UPRIGHT VERTICAL ASSEMBLY 2 REQ'D @ L1U1 TRUSS A + L3U3 TRUSS B

CK'D BY TCF OK'D BY KMH
November 9, 2011
RESUBMIT APPROVED As Noted
BY KMH DATE 9/10/2012

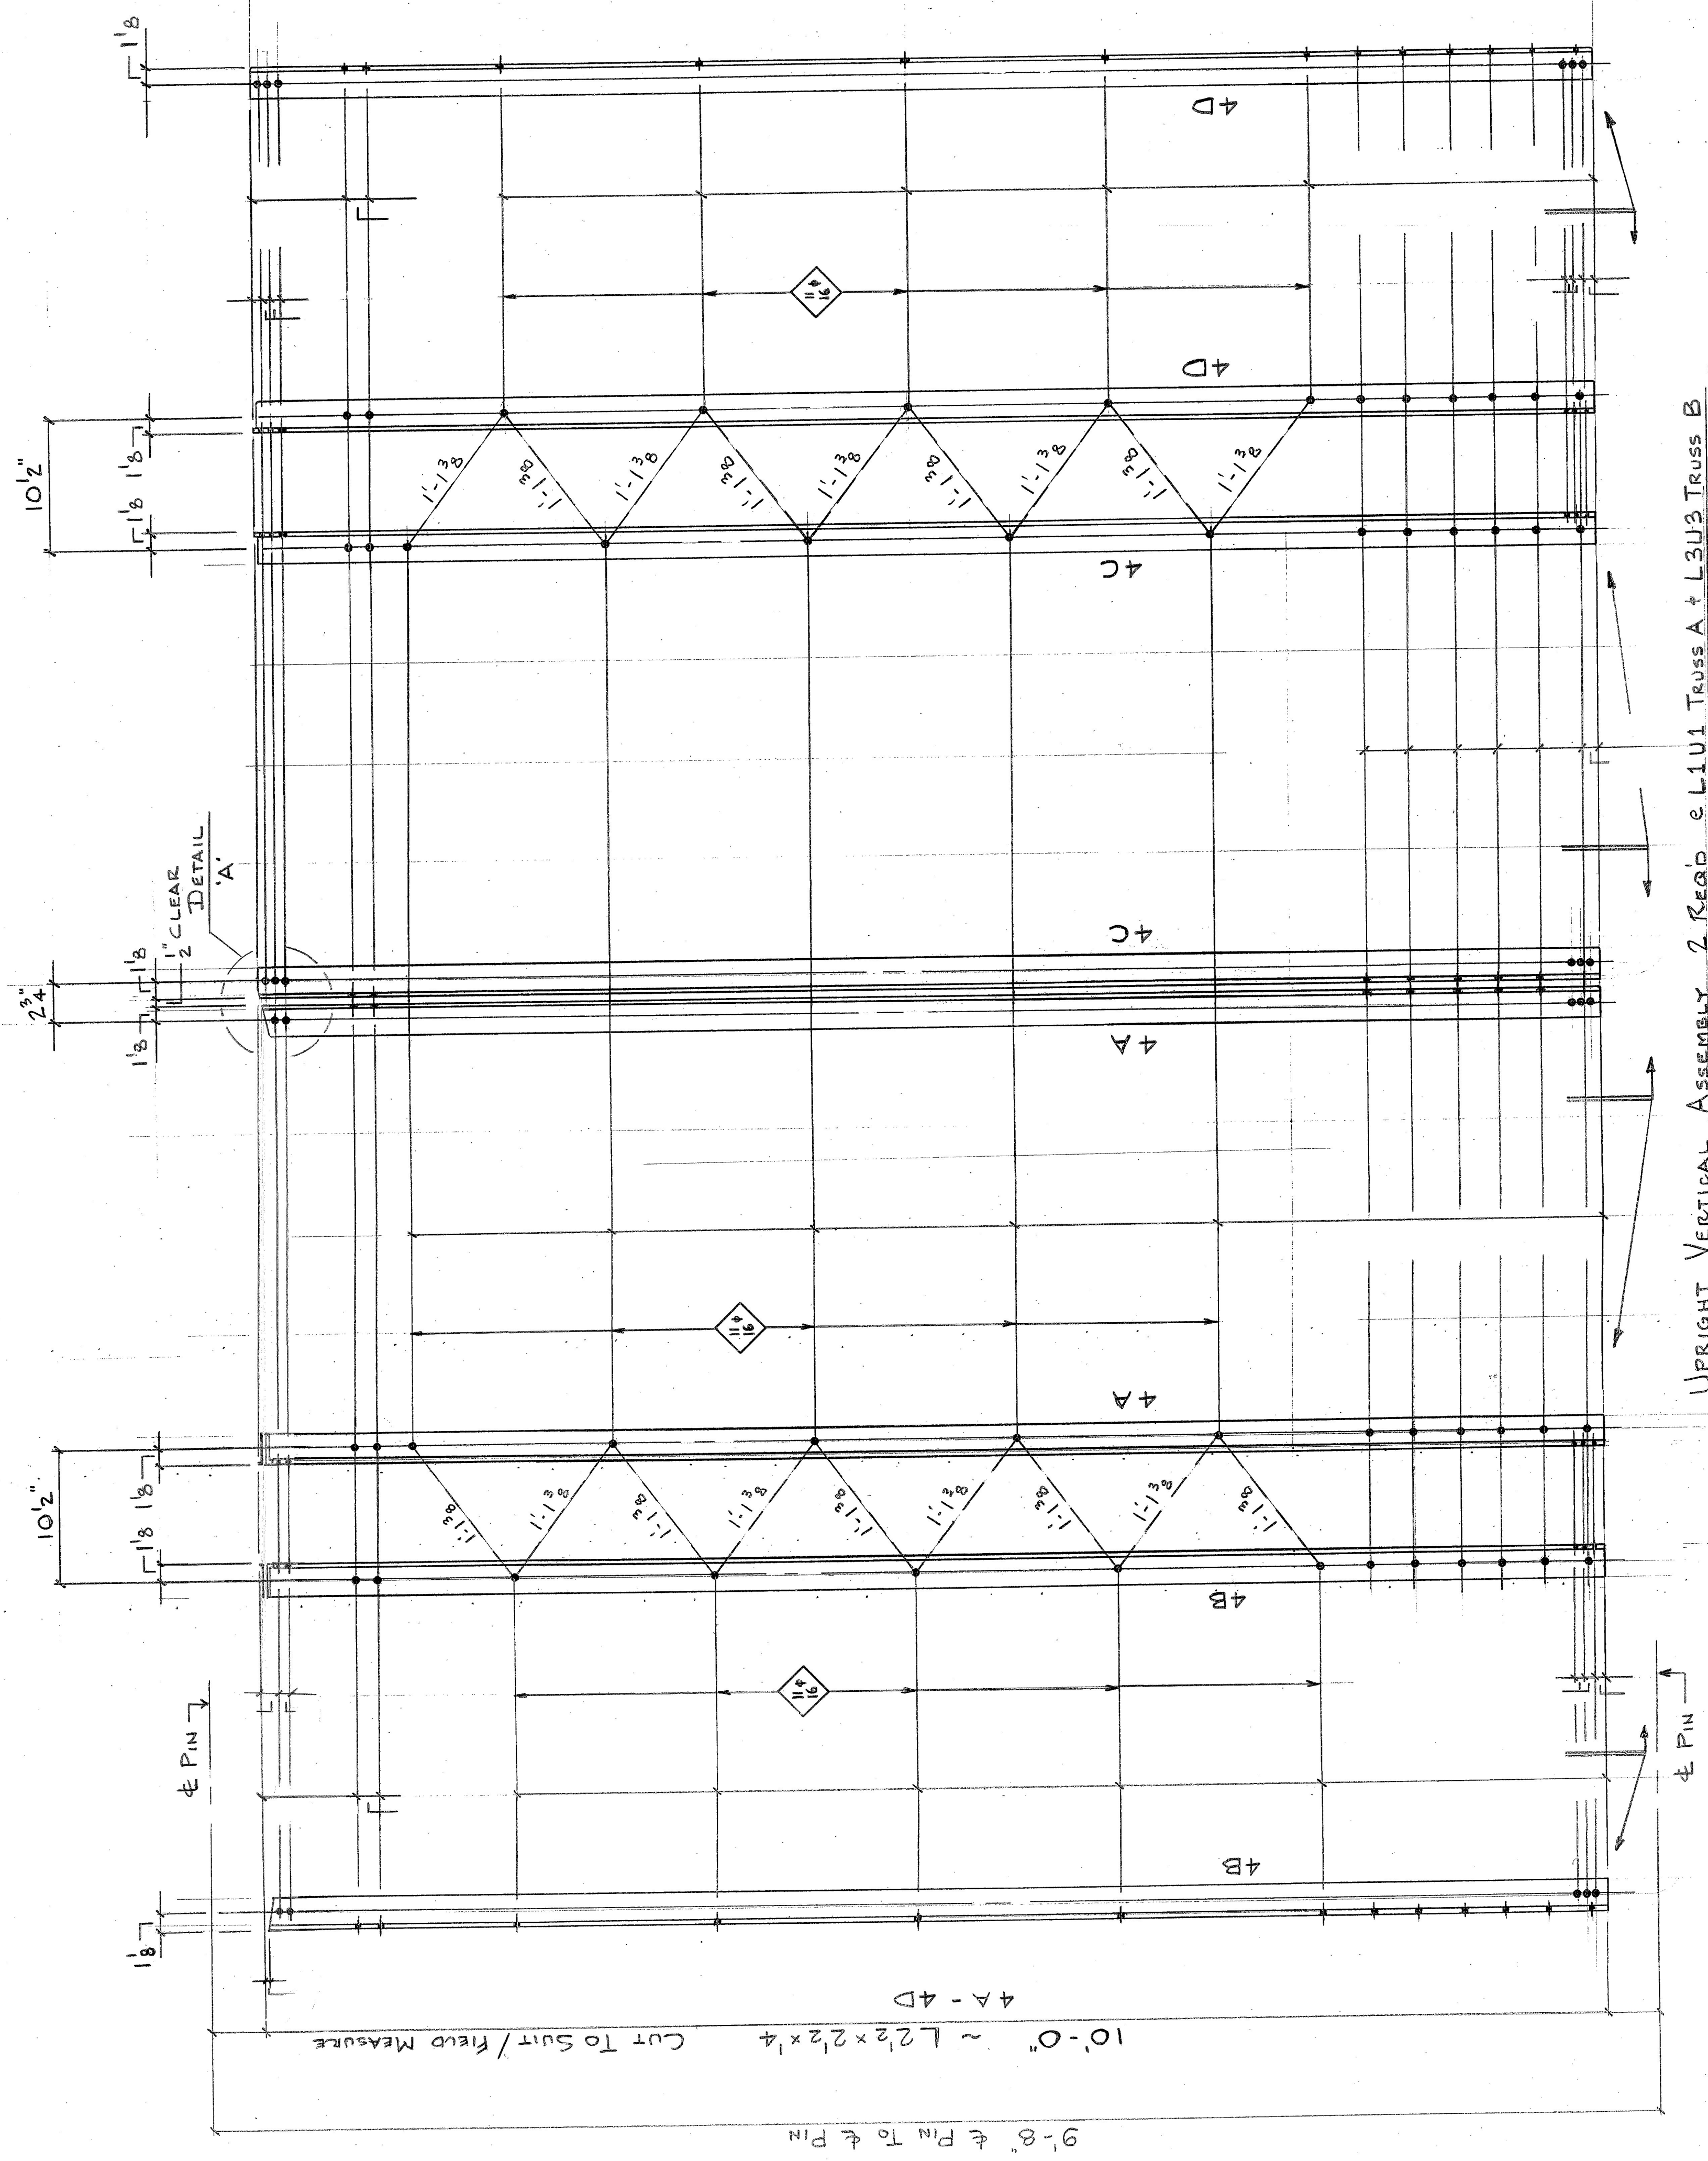
The replacement of members BP1, U1-U2, U2-U1', and BP1' necessitates different details than shown on this sheet. See Sheets 10-13 (1/4-4/4) for modifications.
